Rev B and D limitations and corrections

Silicon identification

This errata document covers the first group with rev B and rev D.

Figure 4. VDD steady, VDDQ falls below its LVD threshold**Figure 5. VDDQ steady, VDD falls below its LVD threshold, but not below 1.2 V**

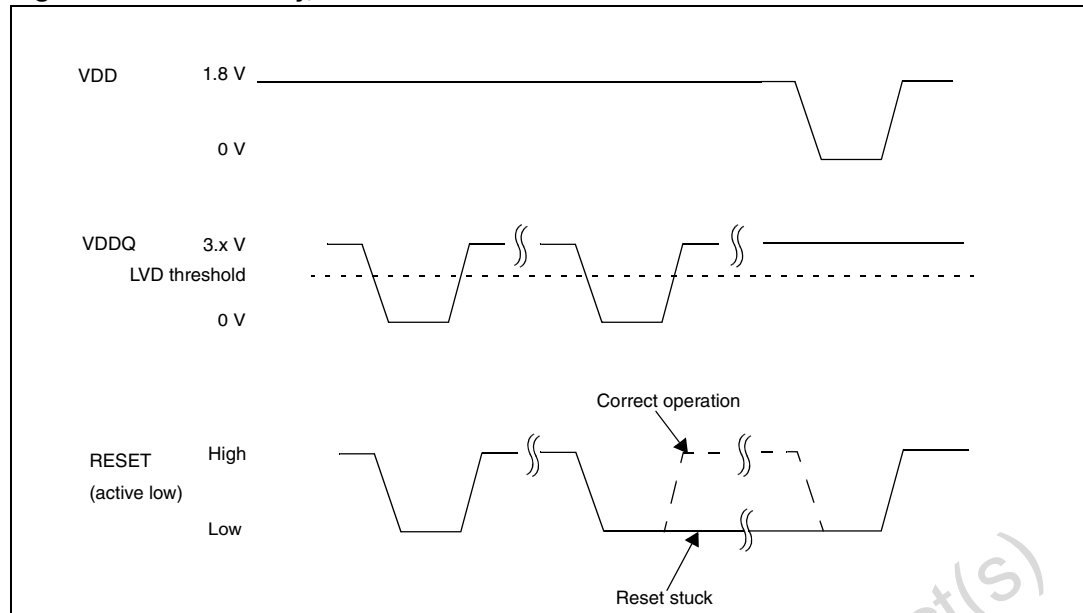
Silicon Limitation: The LVD logic is able to detect the first occurrence of VDD or VDDQ voltage drop that goes below the threshold voltage and it correctly generates an internal reset signal to the CPU and system. However, for subsequent drops of VDD or VDDQ voltage below threshold, the LVD logic generates an active internal reset signal, but the signal remains active (is stuck) even after VDD or VDDQ rises above the threshold again. The CPU is hung in a state of reset. A power cycle is needed on VDD to clear the stuck reset and release the CPU.

Figure 4 illustrates the first case, when VDD is steady, but VDDQ falls below its LVD threshold. You'll see that the generated reset signal during the first drop of VDDQ is correct, and the reset is correctly deactivated when VDDQ returns to normal voltage. However, the second, and subsequent drops, of VDDQ will cause an active reset which remains active even after VDDQ returns to normal level. Only after VDD voltage goes through a power cycle will the reset signal deactivate.

An external reset supervisor device can be used to drive the RESET_INn input pin on the STR9. The LVD must be switched off in this case. This limitation will be fixed in the STR91xFA series.

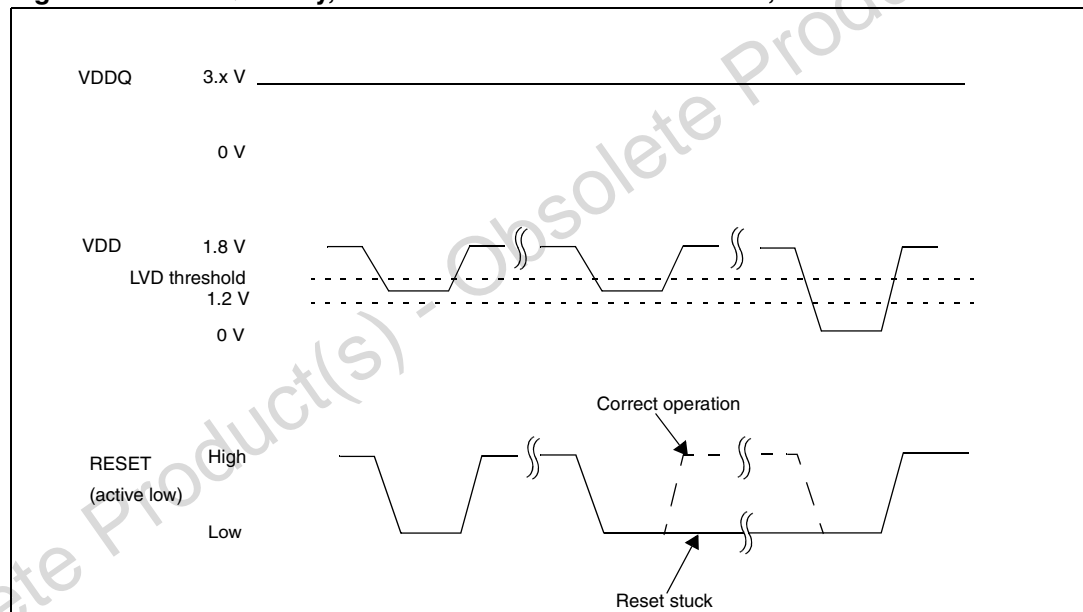
Figure 5 illustrates the second case, when VDDQ is steady, but VDD falls below its LVD level, but not below 1.2 V (power-on-reset level). You'll see that the generated reset signal during the first drop of VDD is correct, but the second and subsequent drops of VDD will cause an active reset which remains active even after VDD returns to normal level. Only after VDD voltage goes through a power cycle (drops below 1.2 V) will the reset signal deactivate.
